**DOCUMENT 00 91 02
ADDENDUM NO. 2**

PROJECT: 2024 Smith and Spillane MS Renovations
BID DATE: **Thursday, February 20, 2025 (no Change)**
FROM: Carolina Weitzman, A.I.A.
Natex Corporation Architects
447 Heights Blvd, Houston, TX 77007
TO: **Prospective Bidders**

SMITH MS

PLUMBING UNDERFLOOR PLAN - AREA 'F'

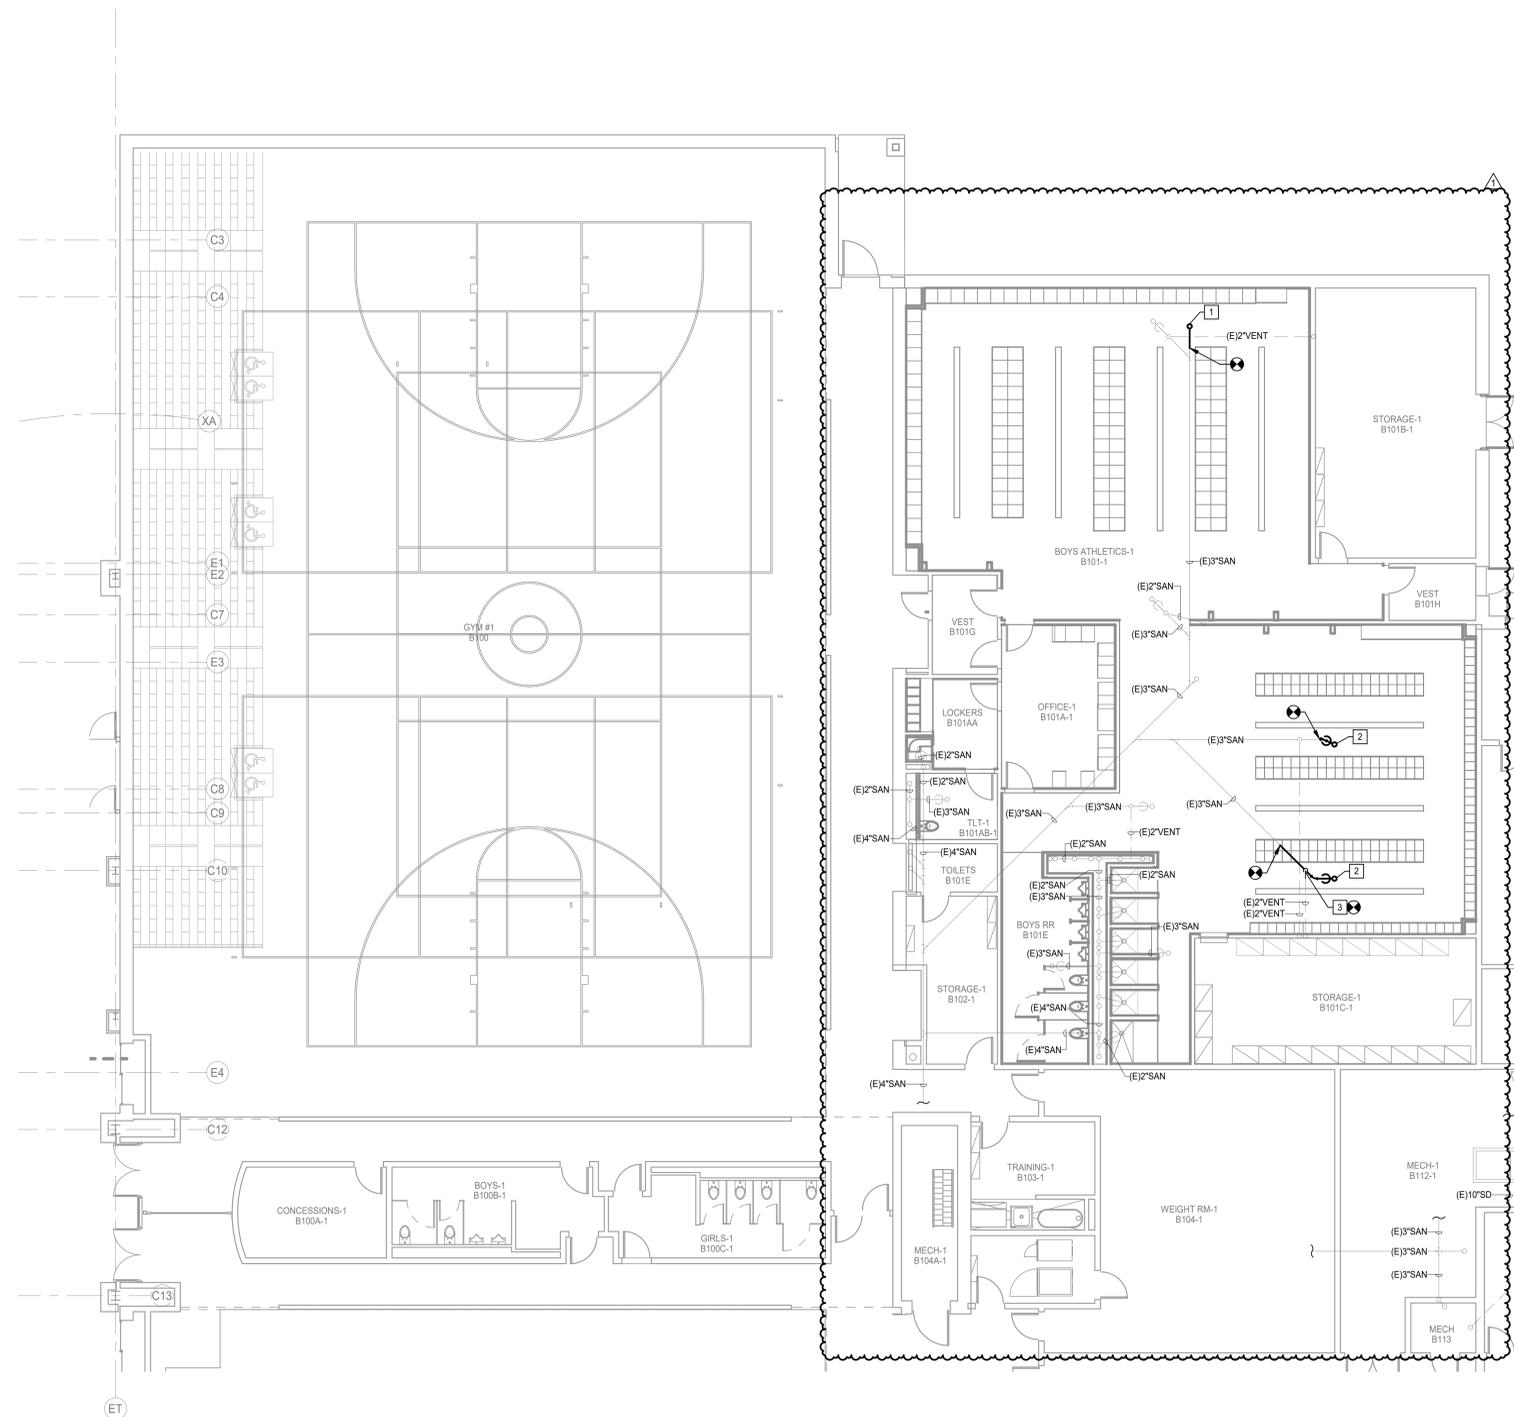
24. P2.06 – PLUMBING UNDERFLOOR PLAN – AREA ‘F’
 - a. Refer to revised sheet for revised scope in central plant.
25. P2.07 – PLUMBING UNDERFLOOR PLAN – AREA ‘G’

PLUMBING UNDERFLOOR PLAN - AREA 'G'

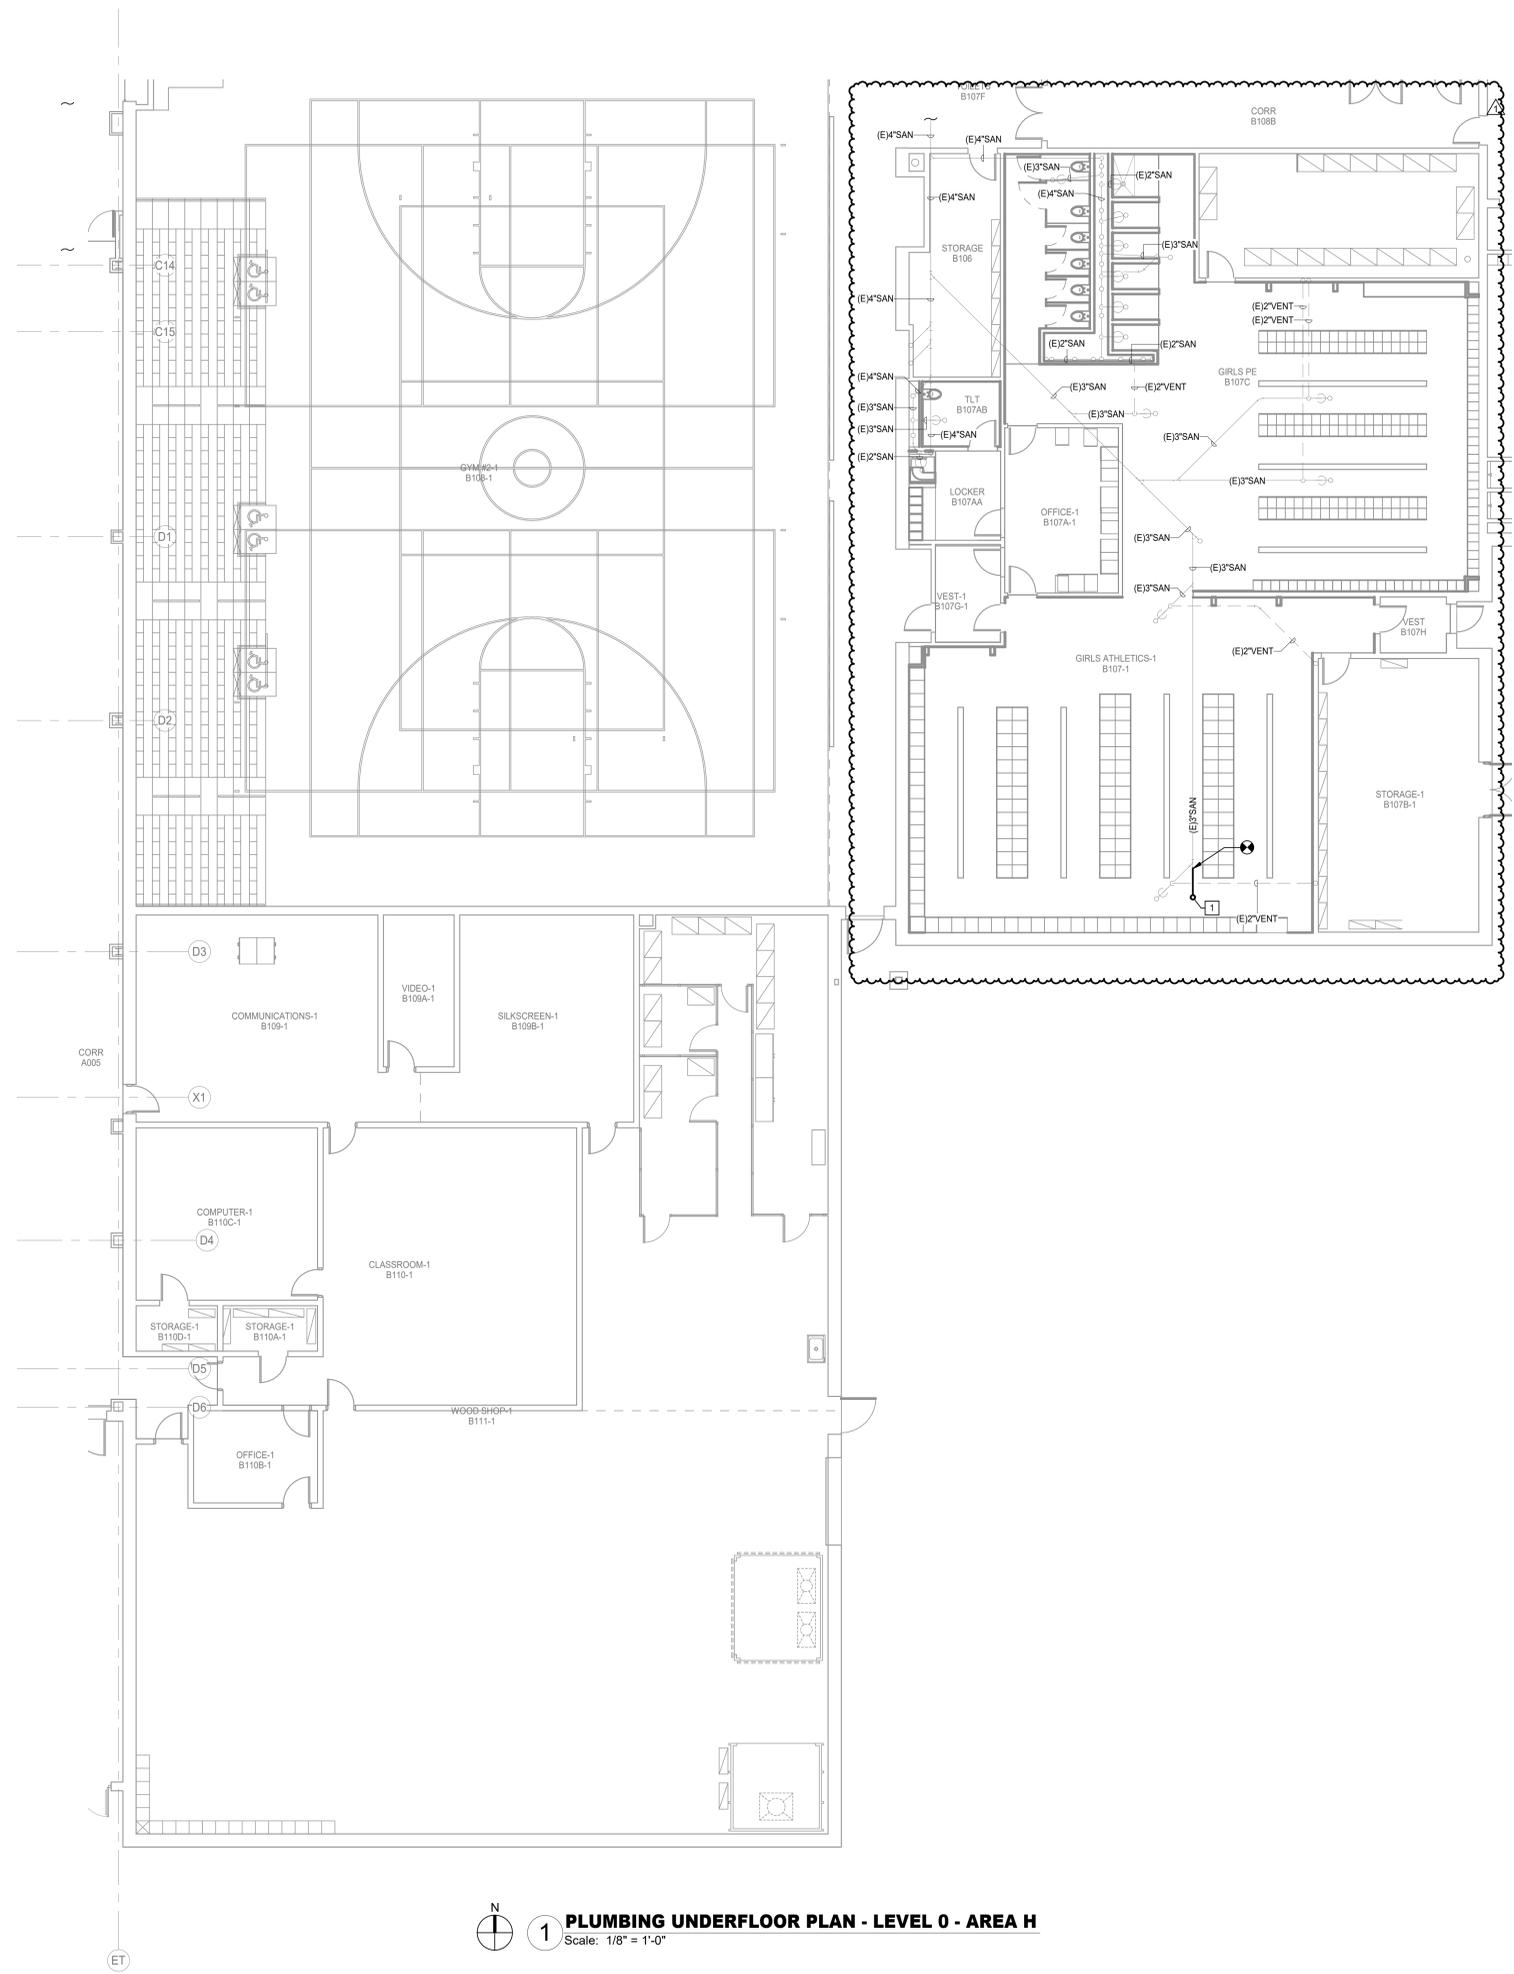
- a. Refer to revised sheet for revised scope in locker room.
26. P2.08 – PLUMBING UNDERFLOOR PLAN – AREA ‘H’
 - a. Refer to revised sheet for revised scope in locker room.

PLUMBING FIRST FLOOR PLAN - AREA 'G'
P3.07

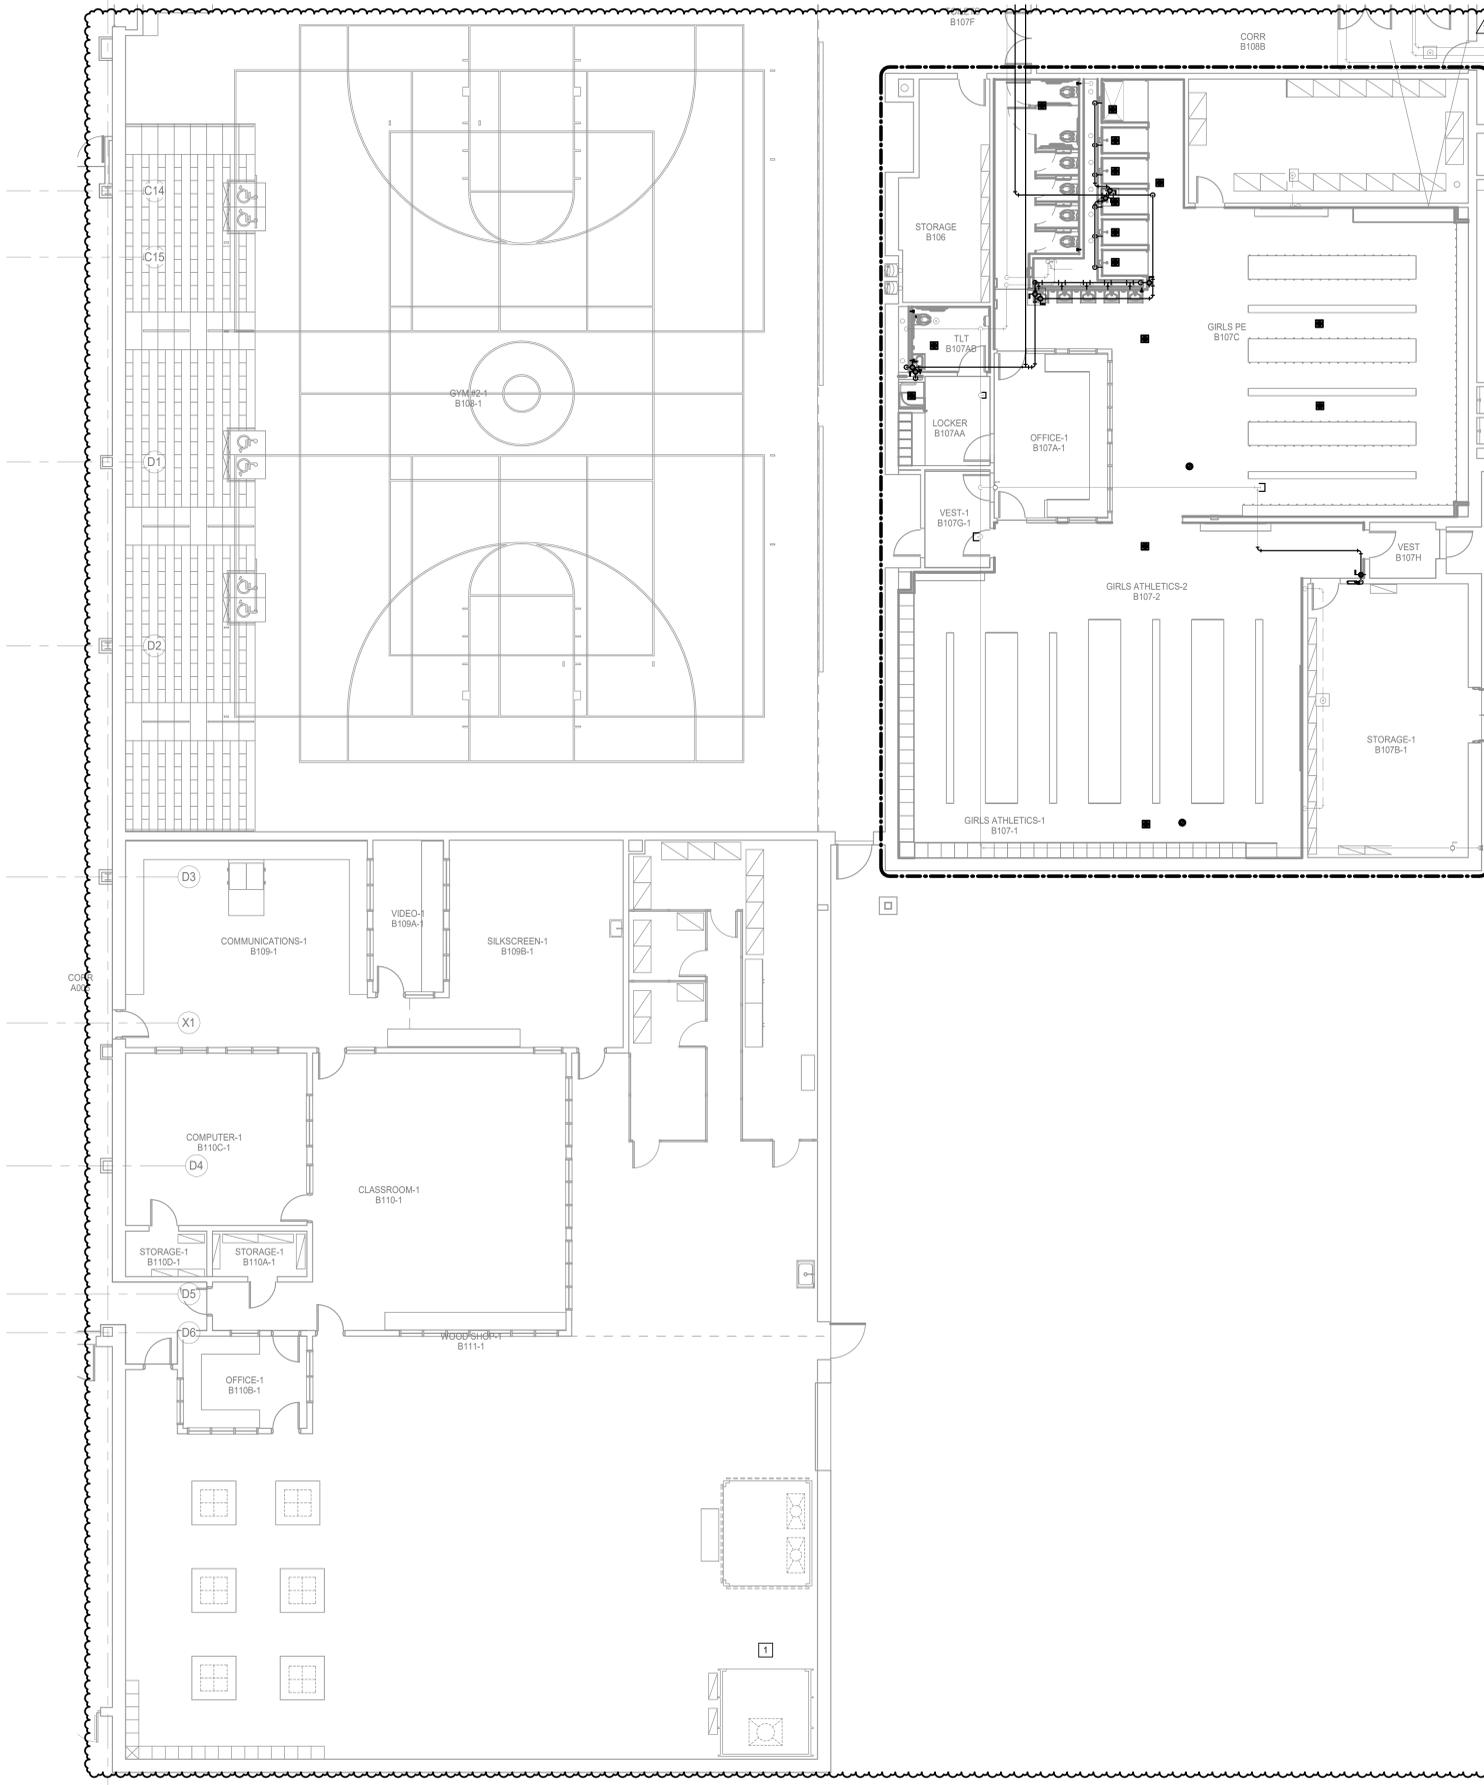
- a. Refer to revised sheet for clarification for mechanical condensate drain and detail reference for central plant.
31. P3.07 – PLUMBING FIRST FLOOR PLAN – AREA ‘G’

PLUMBING SECOND FLOOR PLAN - AREA 'A'
P3.10

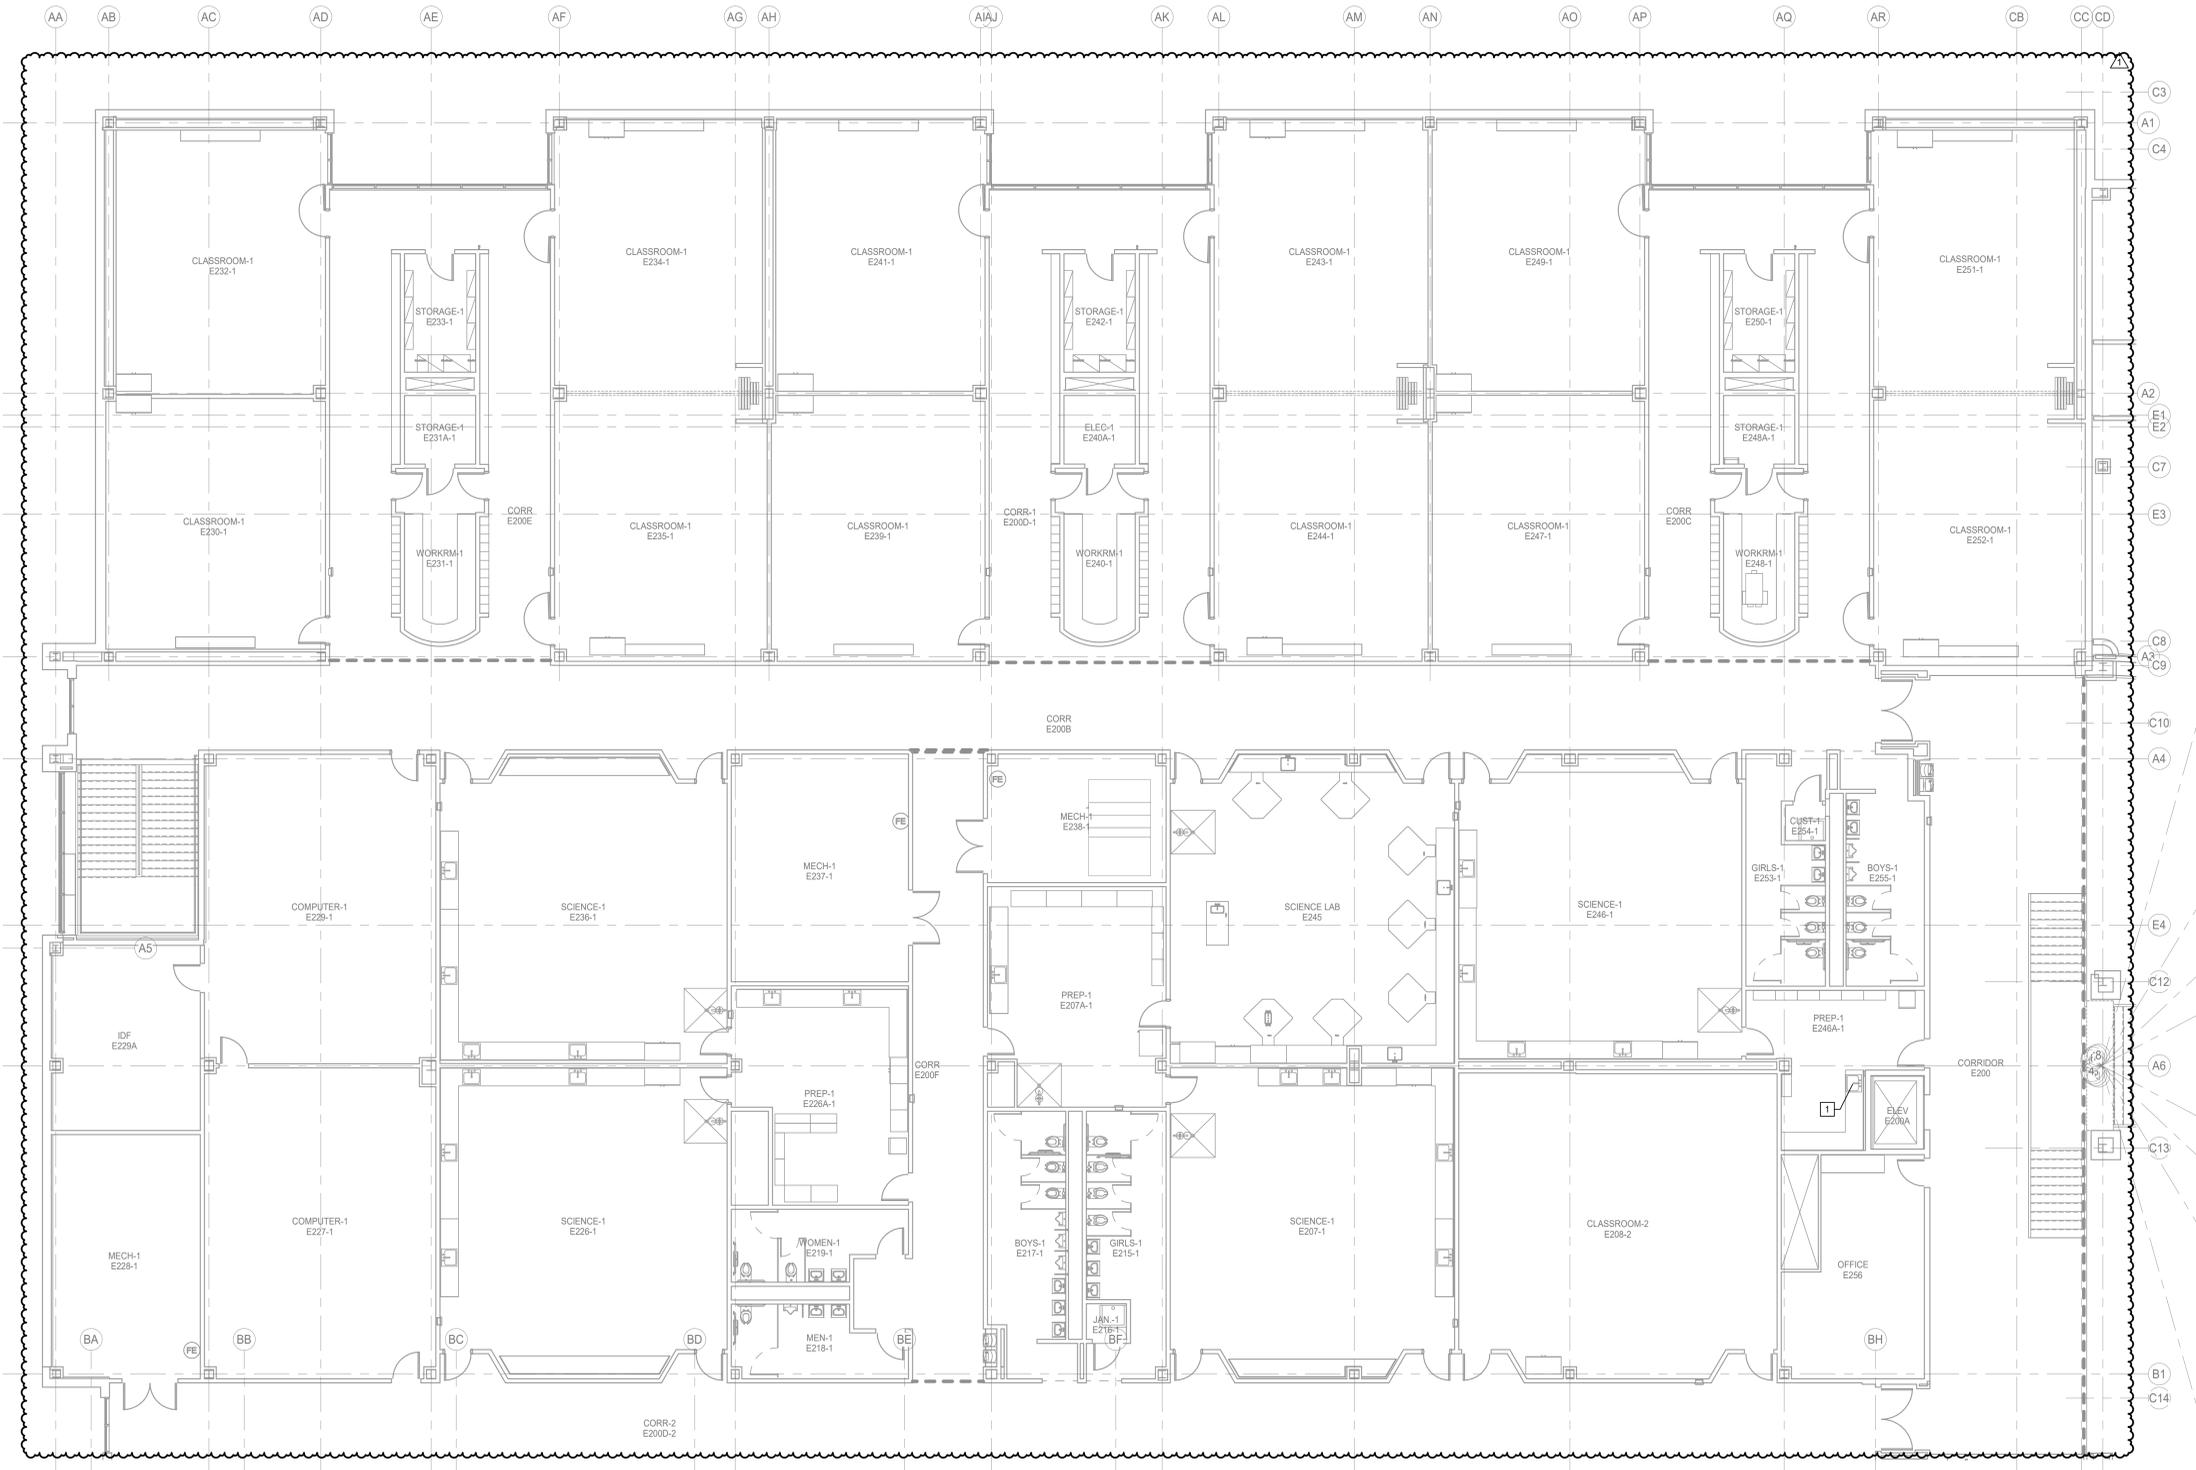
33. P3.10 – PLUMBING SECOND FLOOR PLAN – AREA ‘A’
 - a. Refer to revised sheet for coordination of mechanical condensate.
34. P3.11 – PLUMBING SECOND FLOOR PLAN – AREA ‘B’
